DEPARTMENT OF HAWAIIAN HOME LANDS  
STATE OF HAWAII

**ADDENDUM NO. 2**

PAPAKOLEA SUBDIVISION SEWER IMPROVEMENTS  
AUWAIOLIMU SLOPE STABILIZATION AND SEWER LINES C & C-1 IMPROVEMENTS

**IFB-17-HHL-011**

**TYPICAL SECTION – ANCHORED WIRE MESH**  
**STA. 0+75 TO 3+50**  
SCALE: 1" = 10'

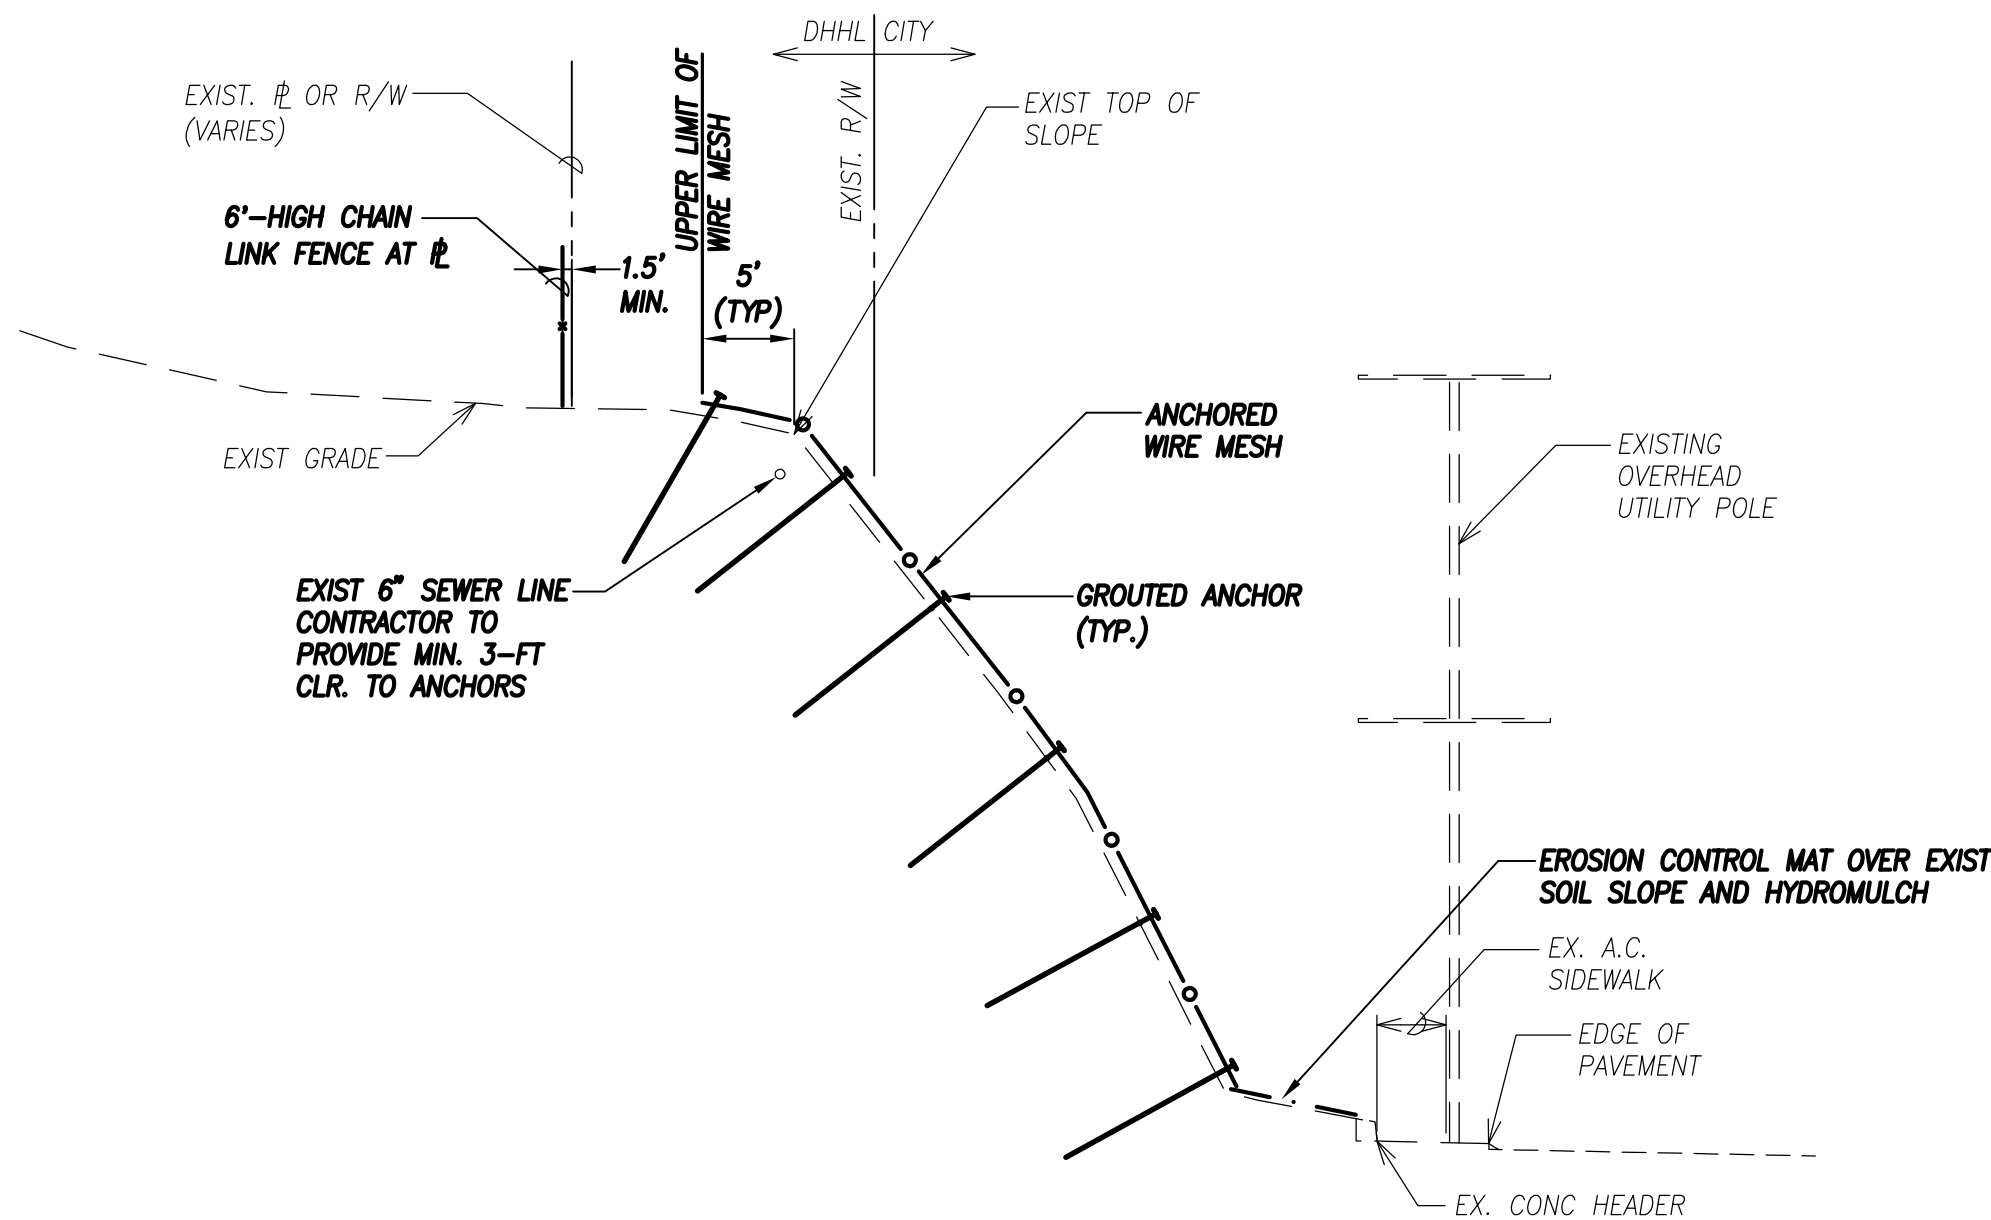
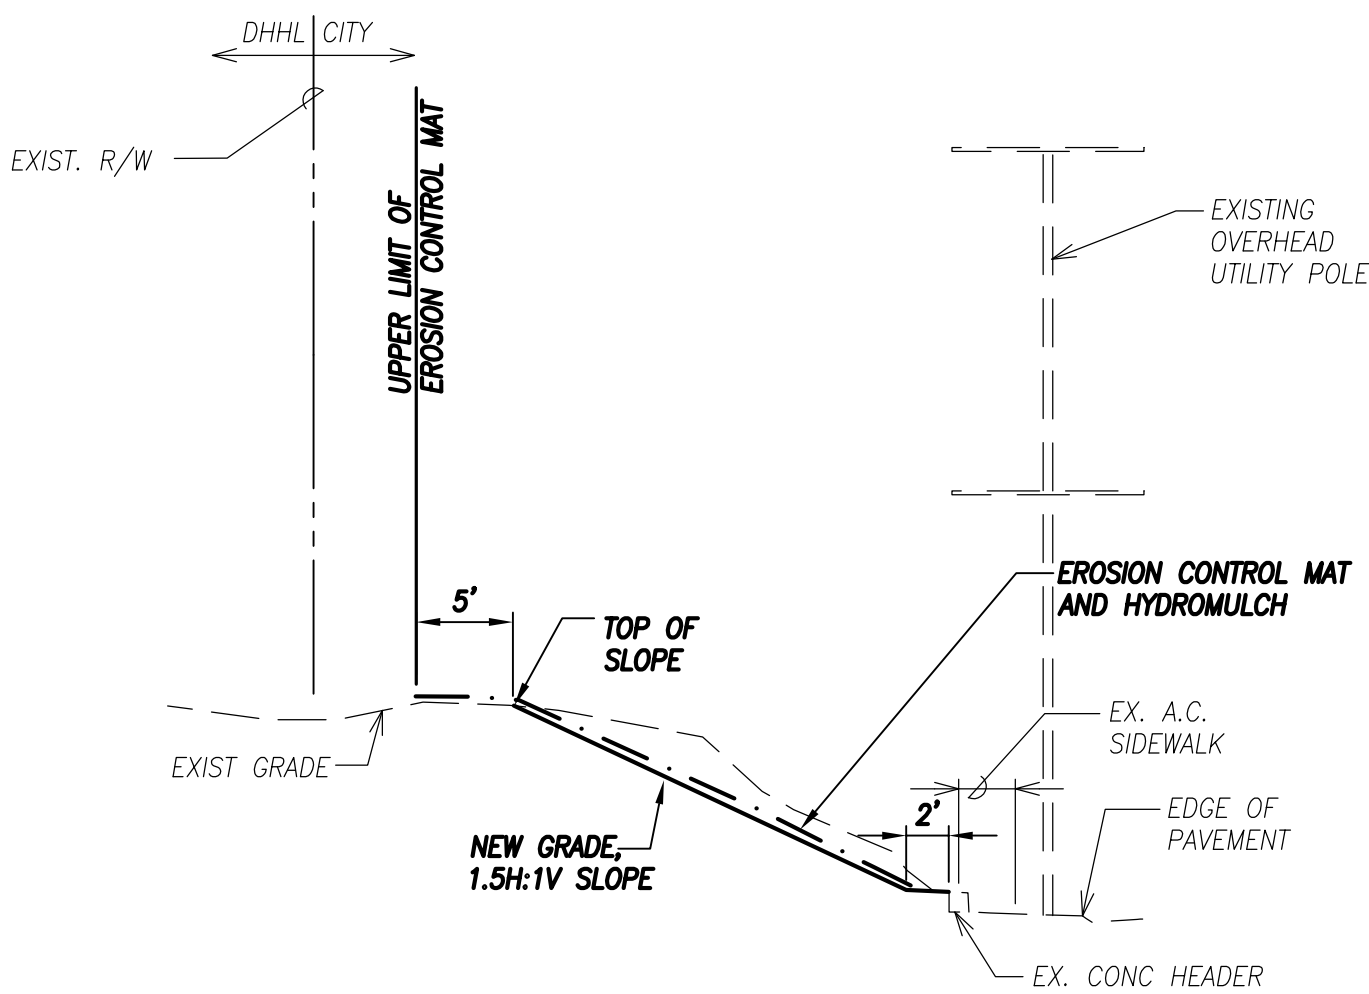
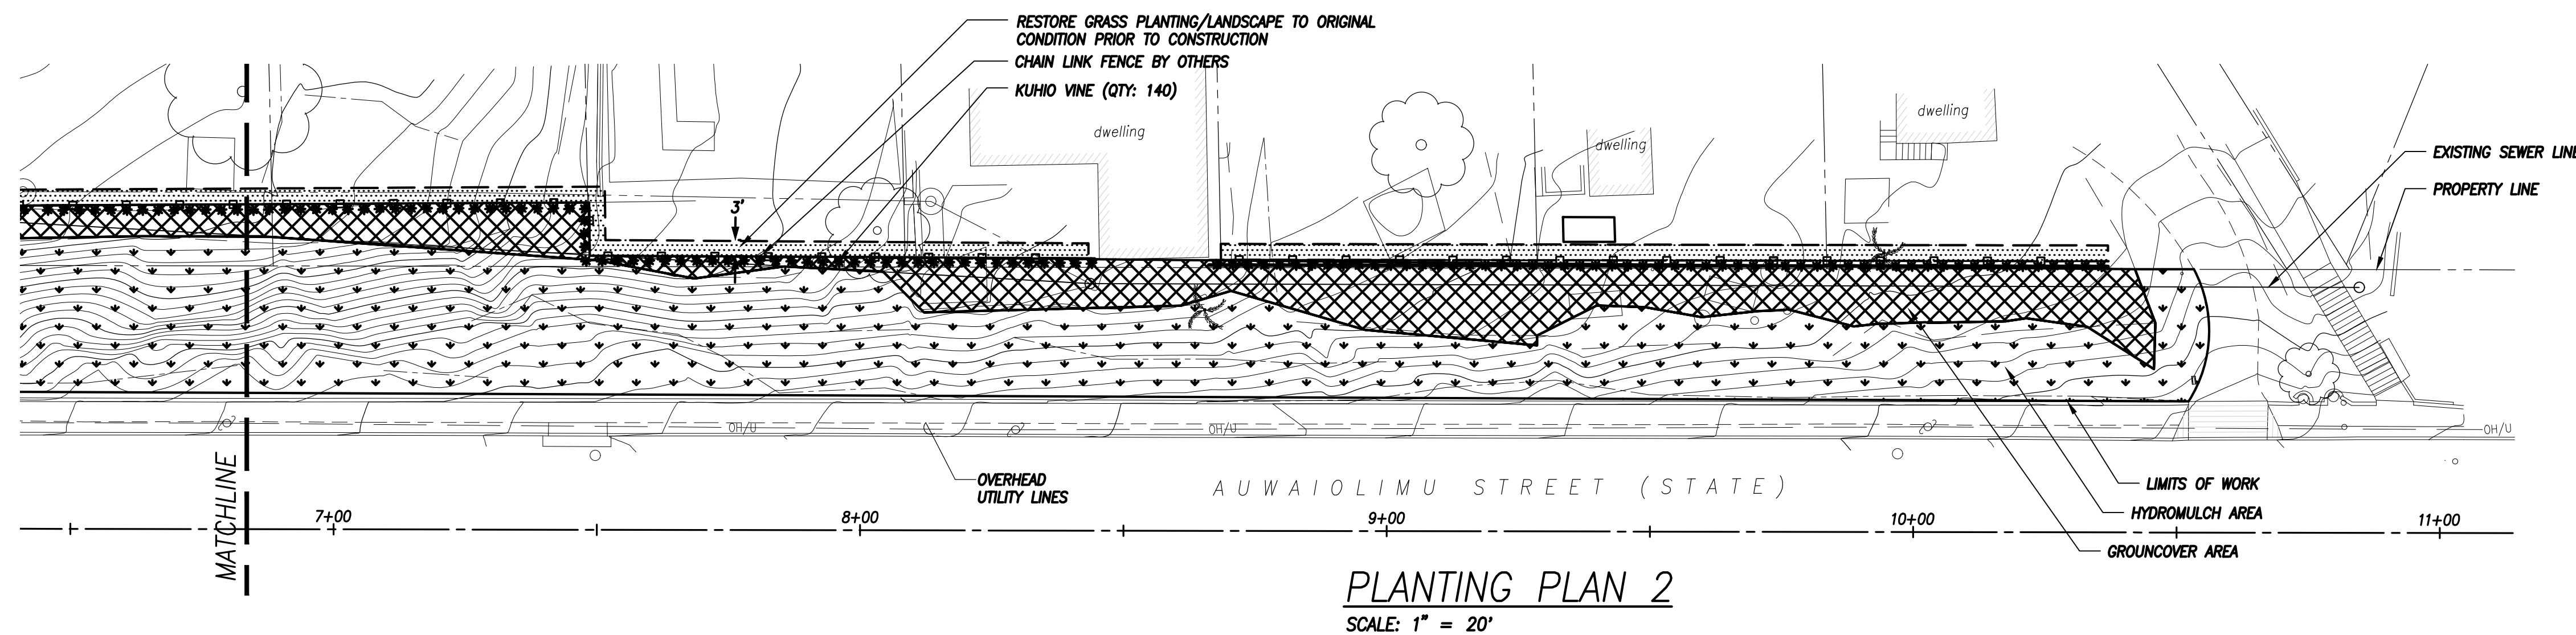
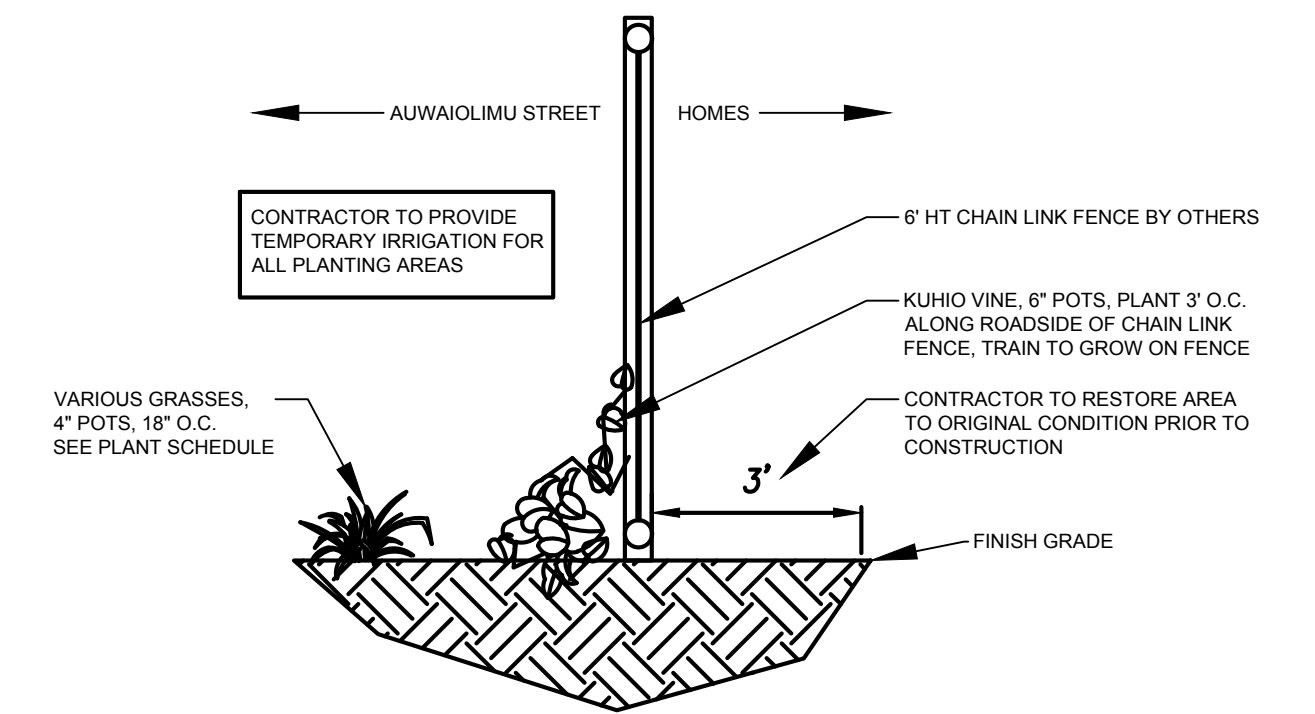
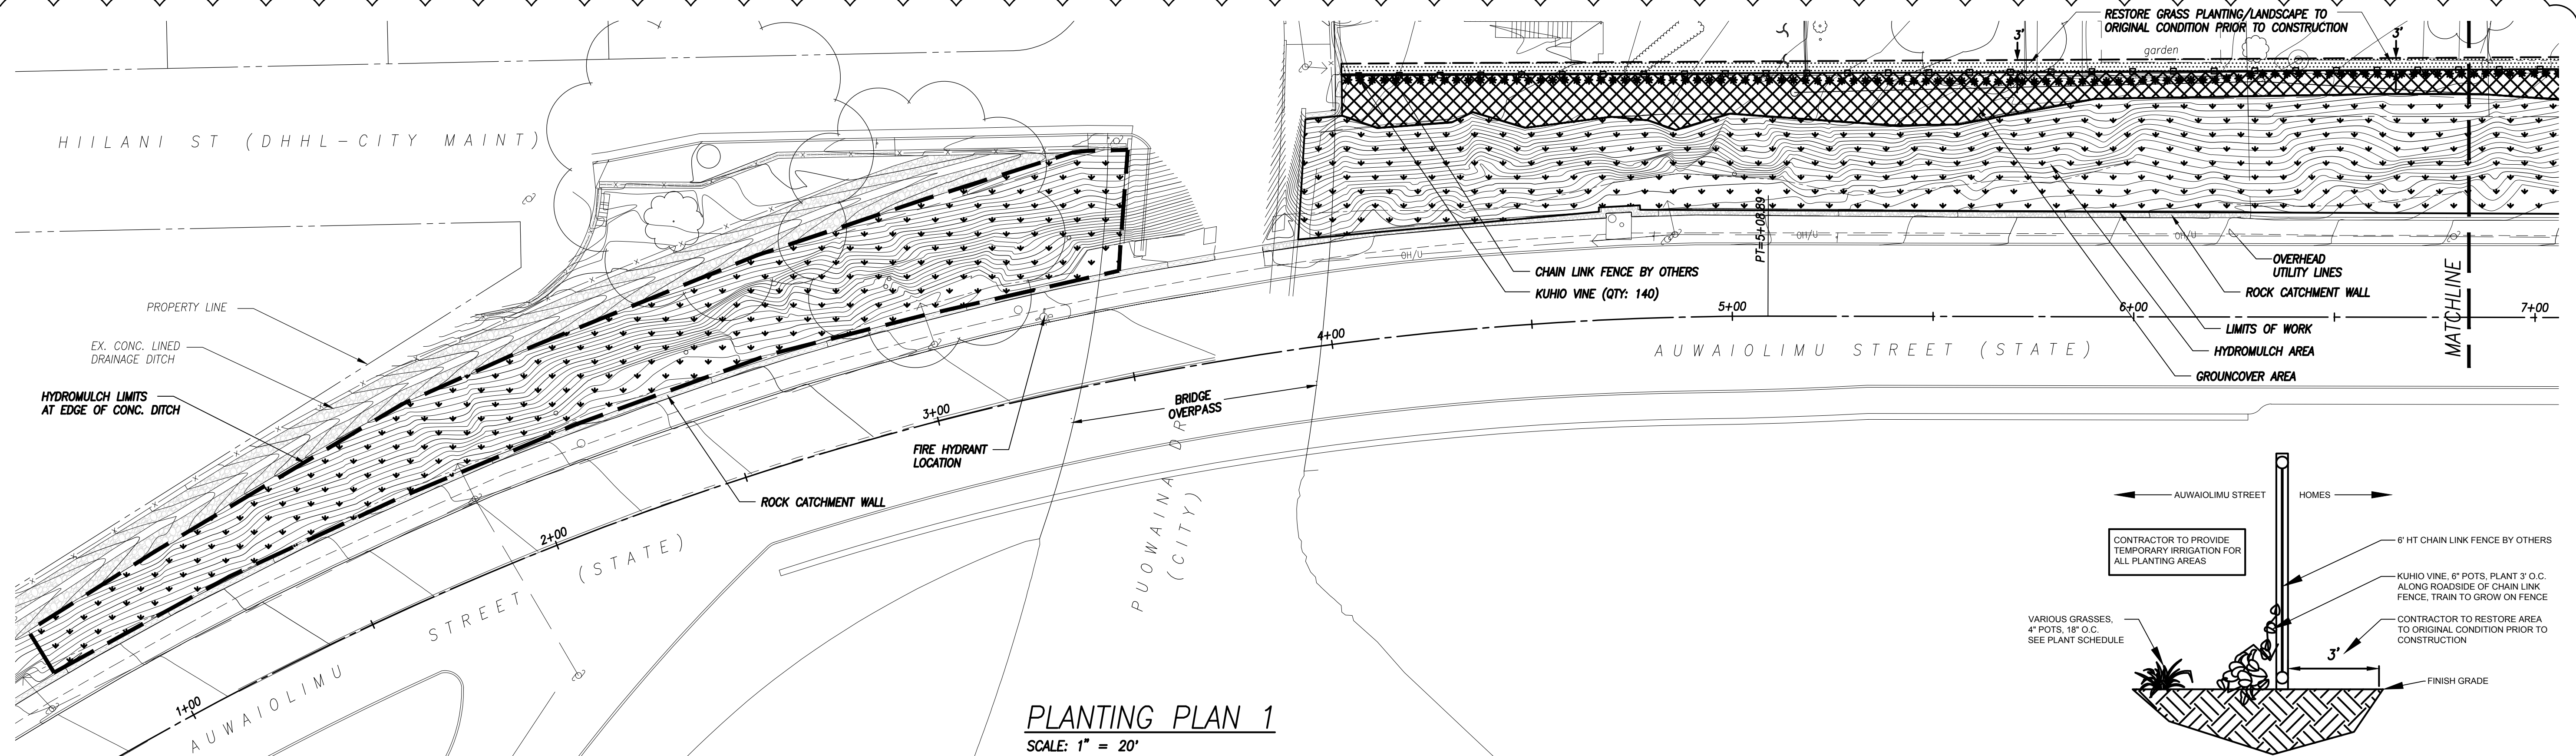
ENGINEER	AM	REVISION	3/27/17	ADD 2: REMOVE EROSION CONTROL MATTING UNDER ANCHOR WIRE MESH	AM	DHHL
DRAFTSMAN	SF	DATE		BRIEF	BY	APPROVED
CHECKED BY	AM/JN					
		R. M. TOWILL CORPORATION Department of Hawaiian Home Lands PAPAKOLEA SEWER IMPROVEMENTS AUMAIOLU SLOPE STABILIZATION & SEWER LINES C & C-1 IMPROVEMENTS Papakolea, Honolulu, Oahu, Hawaii				
		TYPICAL SECTIONS				
THIS WORK WAS PREPARED BY ME OR UNDER MY SUPERVISION AND CONSTRUCTION OF THIS PROJECT WILL BE UNDER MY OBSERVATION. "OBSERVATION OF CONSTRUCTION" IS DEFINED IN CHAPTER 16-115, HAWAII ADMINISTRATIVE RULES ENTITLED "PROFESSIONAL ENGINEERS, ARCHITECTS, SURVEYORS AND LANDSCAPE ARCHITECTS"		APR 2018 LIC. EXP.

## PLANTING PLAN

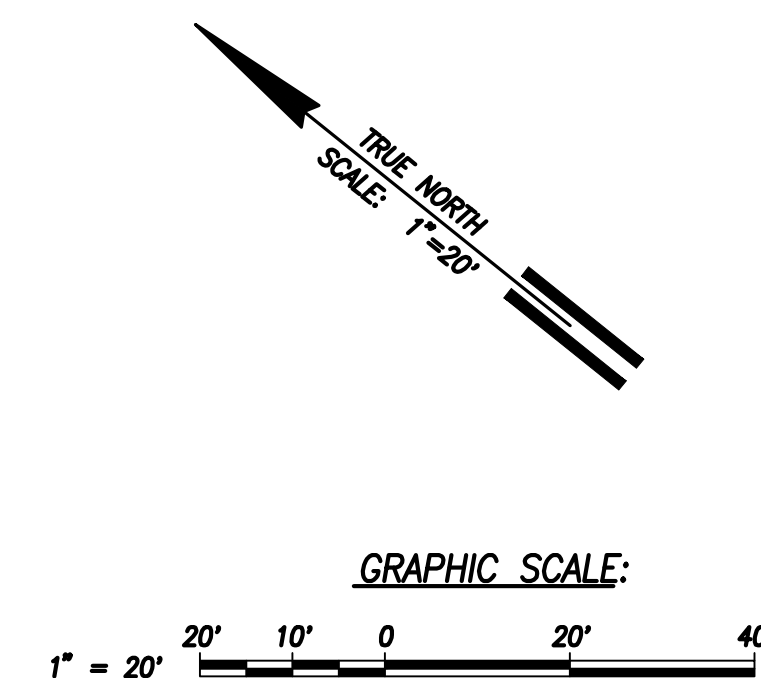
8. **Regarding Sheet Regarding Sheet L-1, please confirm the quantity of vines required, the listed quantity of 140 seems less than what is drawn on the plans.**

ENGINEER	LI				
DRAFTSMAN	KY	3/27/17		ADD 2: Rmw trees; extend vines	LI
CHECKED BY	LI	REVISION	DATE	BRIEF	BY
				APPROVED	DHHL

Answer: Quantities revised, See revised L-1 issued above in Item No. 5 of this addendum.
